**Response to Submissions  
– Planning Reference  
ACP-323873-25**

Kingston Park and Millers  
Lane – Public Park and  
Urban Realm Project

Client: **Galway City Council**

Document Title: **Response to Submissions – Planning Reference ACP-323873-25**

### Active Travel Upgrades

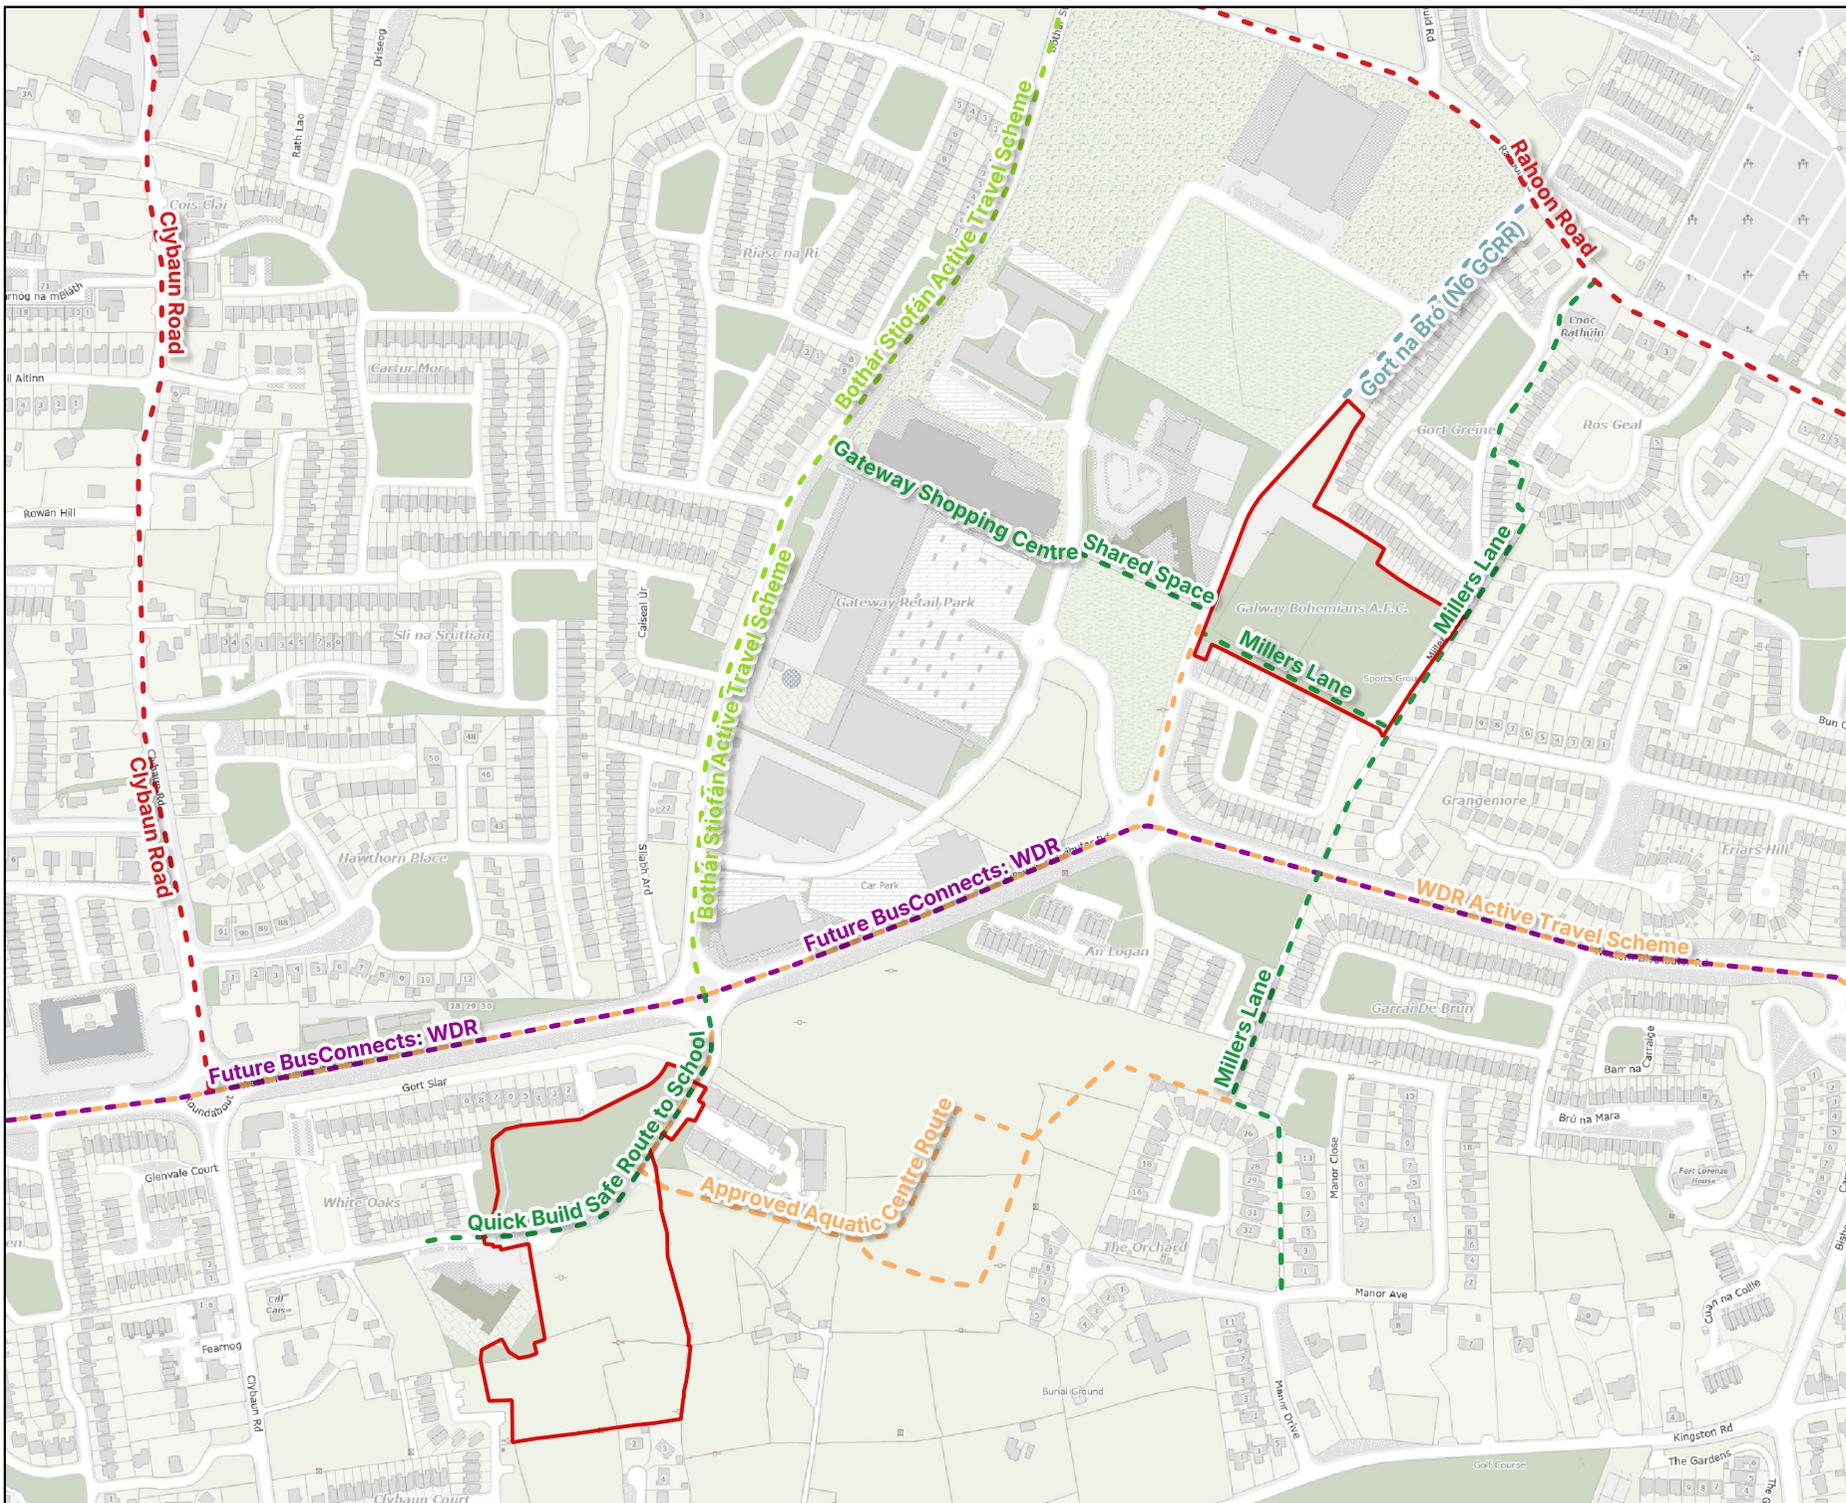
The concerns expressed by the Gort Siar Residents regarding traffic, illegal parking, and access to their estate were key considerations during the design process of Kingston Park. These matters directly informed the creation of the proposed drop-off loop design serving the park and Knocknacarra National School, as well as the inclusion of a Safe Routes to School active travel path. The looped parking and drop-off arrangement is specifically designed to facilitate the smooth operation of the school during pick-up and drop-off times. This design intervention addresses the current congestion caused by the lack of turning facilities on the Altan Road, which is resulting in incidences of illegal parking. The new design is intended to alleviate this issue and should assist in reducing problems associated with illegal parking and traffic blocking access to the Gort Siar estate.

Active travel upgrades to the Altan Road will be delivered as part of the approved nearby swimming and sports facility (Pln Ref. 24/60370). Active travel upgrades to Gort na Bró will be delivered in part through the N6 Galway City Ring Road (GCRR) scheme (should approval be granted), as well as through the approved Glenveagh Large-scale Residential Development (Pln Refs. 23/3; LH61.318687). These projects, together with completed works in the area, are illustrated in **Figure 2-1**.

Together with the wider programme of active travel upgrades in Knocknacarra, the result of these many schemes is the creation of an extensive and high-quality active travel network in the Knocknacarra area, much of which is already under construction or approved for delivery. It is submitted that as a result, both Kingston Park and Millers Lane, as well as the Knocknacarra NS, will be safely and conveniently accessible by walking and cycling. This network directly supports Galway City Council's stated policy objectives to facilitate modal shift towards sustainable transport across Galway City and in the Knocknacarra area. We submit that it will, in turn, reduce reliance on private car use and thereby mitigate traffic impacts in the vicinity of the Gort Siar estate.

Figure 2-2: Extract of Landscape Drawing No. P612-KIN-LD-GA-102, submitted with the original application documentation, showing Section A-A and Section C-C around the site boundary with Gort Siar. Not presented to scale.

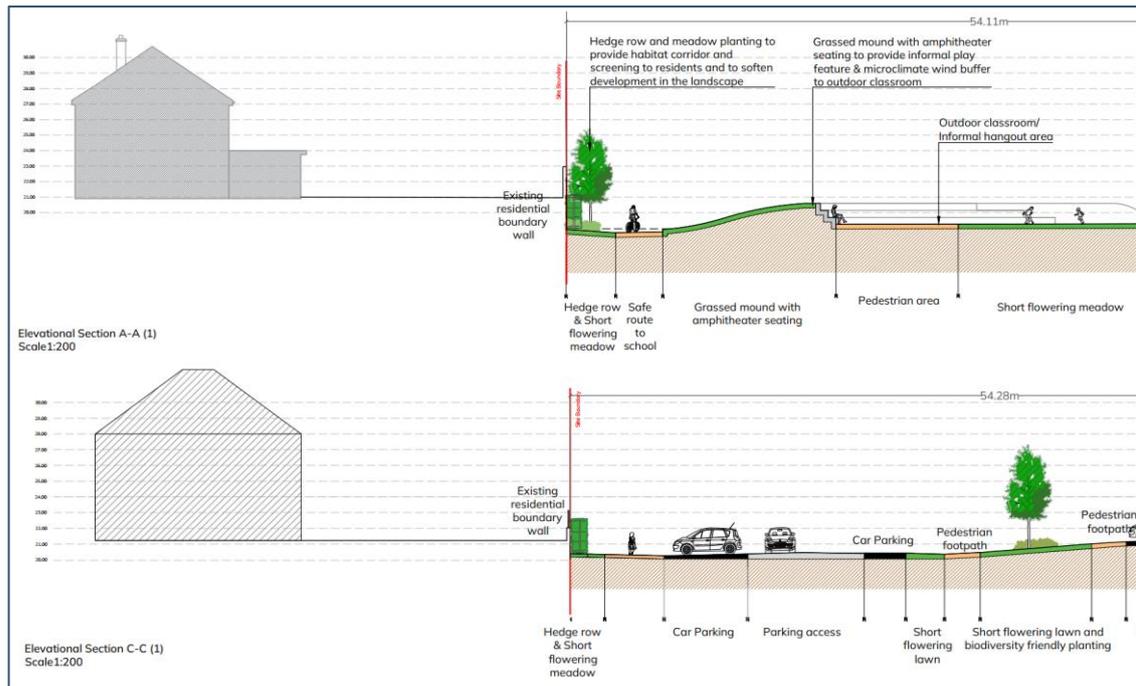
- The potential for anti-social behaviour in the new park.
- The potential for noise disturbance due to the location of the walkway along the rear boundary wall of Gort Siar and the location of the outdoor classroom.

It is anticipated that the proposed pathway, which is designed as a Safe Routes to School-style active travel path, will primarily generate activity during school hours. The Applicant wishes to draw the attention of the Commission and the Gort Siar Residents to **Sections A-A and C-C in Dwg. P612-KIN-LD-GA-102**, prepared by DRLA and submitted with the original application, which is also reproduced in **Figure 2-2** (overleaf). In Section A-A, it should be noted that there is an almost 2m level difference between the ground level of the back garden of the Gort Siar residences and the proposed active travel path, resulting in the private residential space being elevated above the pathway. In **Section C-C**, there is a similar but smaller level difference of approximately 1m. In addition, the existing rear boundary walls of those residences vary slightly but are generally approximately 2m high from the ground level of all the back gardens. **Additional planting is proposed along the boundary with the Gort Siar estate to provide screening, noise buffering and to soften the appearance of this level change.** There is a minimum separation distance of approximately 16m maintained between all houses in Gort Siar and the active travel path, which is in line with the [Sustainable Residential Development and Compact Settlements Guidelines \(2024\)](#). For these reasons, the context of the proposed active travel path in Kingston Park is different from the one at McGrath's field and will enable suitable levels of screening to protect the residential amenity of the Gort Siar Residents.

Similarly, the outdoor classroom has been appropriately set back from the rear boundary with a minimum separation of approximately 28.5m from any of the surrounding residences. The Commission and Gort Siar residents' attention is drawn to **Section A-A of Dwg. P612-KIN-LD-GA-102**. This section clearly shows that the top of the amphitheatre mound will be below the ground level of the back gardens in Gort Siar. The Applicant also wishes to highlight that the amphitheatre will also benefit from an additional layer of *Prunus avium* 'Plena' tree planting, which will provide further screening. **Figure 2-3** (overleaf) shows an example image of this tree species for the reference of The Commission and the Gort Siar residents. This, in combination with the planting proposed between the active travel path and the Gort Siar boundary, results in the outdoor classroom ultimately have two 'layers' of planting which will provide effective visual screening and noise attenuation for the Gort Siar residents. Full details on the proposed boundary treatments proposed along the Gort Siar interface, including layout plans and sections, are detailed in the **Landscape Drawing Pack** submitted with the application.

Figure 2-5: Extract of Lighting Drawing No. 24.2812 P-E100, submitted with the original application documentation, showing illumination from the proposed public lighting. Not presented to scale.

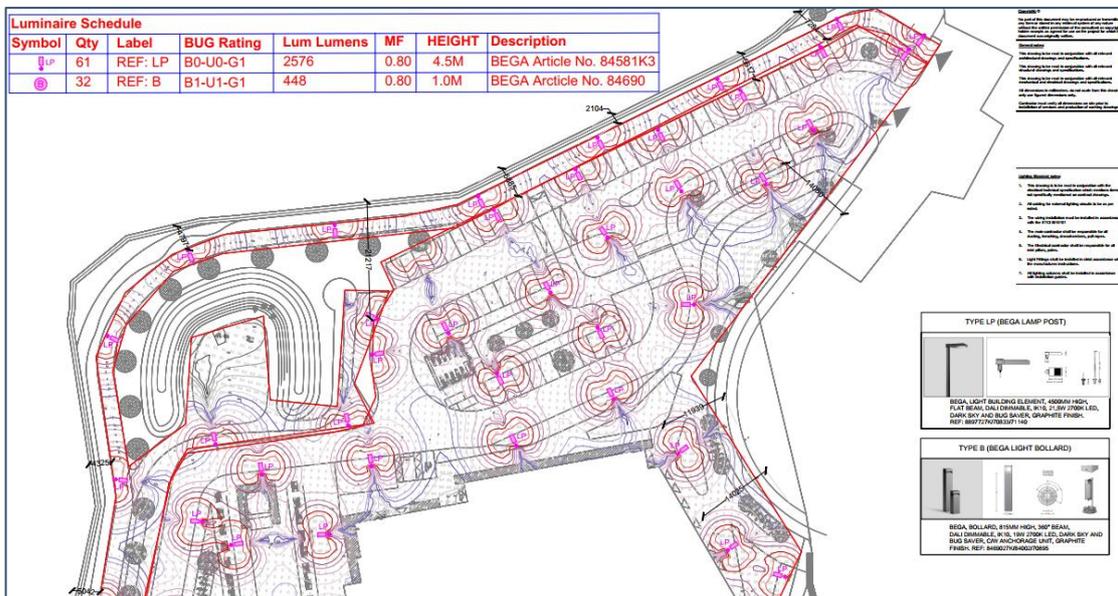
- The potential impact of the proposed floodlights on residential amenity.
- The proposed hours of operation of the café, and queries regarding whether a drinks licence will be associated with the facility.

**Lighting Drawing No. 24.2812 P-E100** illustrates the extent of illumination from the proposed streetlights and is reproduced in **Figure 2-5** for convenience. It is accompanied by the **Kingston Park Lighting Simulation Report**, which provides details on the types of proposed lighting for the public realm. Both documents were submitted with the original application documentation. In areas adjacent to the boundary with Gort Siar, lighting will be provided by lamp posts along the active travel path, within the amphitheatre, and throughout the parking area and plaza areas. These lamp posts are oriented away from the boundary with Gort Siar and employ modern LED fixtures compliant with Dark Sky design standards, ensuring that illumination is directed to where it is needed and that unnecessary light spill is minimised.

In addition, the level differences highlighted in the section above between the rear gardens of Gort Siar and the finished ground levels for the proposed development provide further passive screening. The proposed lamp posts are 4.6 metres high from ground level, which is less than 0.25 metres above the existing boundary wall shown in **Section A-A**. When combined with the directionality of the lighting fixtures, Dark Sky compliance, and the physical screening afforded by boundary treatments and planting, the Applicant is satisfied that the proposed public realm lighting will not result in adverse impacts on residential amenity.

Figure 2-6: Extract of the elevations in Architectural Drawing No. 2412-QNA-XX-XX-DR-A-2040, submitted with the original application documentation, showing the proposed storage and bike shed. Not presented to scale.

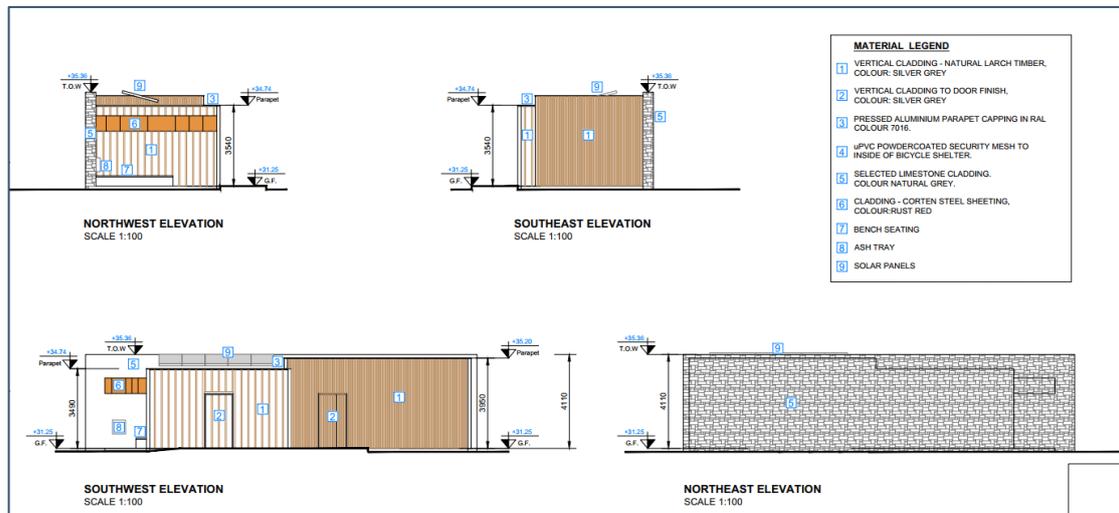
In her submission, Mary Tynan raises a concern that the proposed storage shed, and bike store would exceed the height of her rear boundary wall. The Applicant wishes to clarify that this concern is not supported by the plans and particulars submitted with the application. **Dwg. 2412-QNA-XX-XX-DR-A-2040**, prepared by Quinn Architects and submitted with the original documentation, illustrates the plan, elevation, and section views of the proposed storage shed. This drawing is reproduced in **Figure 2-6** below for convenience.

The northeast elevation shows the rear of the proposed shed as viewed with the boundary wall in front of it. This drawing clearly indicates that the proposed shed will not exceed the height of the existing boundary wall. The only element that could marginally exceed the height of the existing boundary wall will be the rear of the solar panels, which face away from the observer's residence, by a height of 5cm. For context, this dimension is less than the length of the average human thumb. It is extremely unlikely to be visible from ground level due to the depth they are set back and the height difference, nor is it likely that it would be capable of casting a shadow over the wall due to its positioning.

Figure 2-8: Extract of Lighting Drawing No. 24.2812 PE103, submitted with the original application documentation, showing the illumination from the proposed floodlights. Not presented to scale.

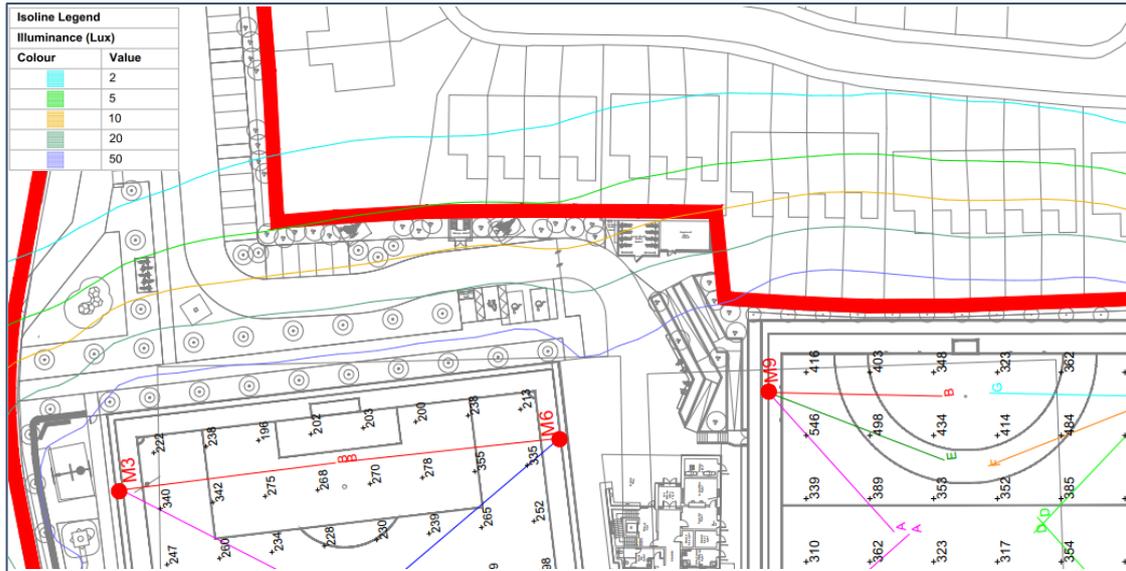
- Potential loss of daylight.
- Potential negative visual impact.
- Potential overlooking and loss of privacy.
- Security and safety risks due to ancillary structures located near rear boundaries.
- Potential for anti-social behaviour.
- Placement and operation of the proposed bin store.

While it acknowledged that a degree of light spill from the proposed floodlights may be perceptible at adjoining residences, it is submitted that there are already existing floodlights on the site. It is noted that no criticisms regarding the current operation of the existing floodlights were raised by the observers in their submissions. The Applicant submits that the proposed provision, which will enable the usage of the latest mitigation technologies and management practices, will not give rise to any additional adverse impacts on residential amenity of the surrounding residences.
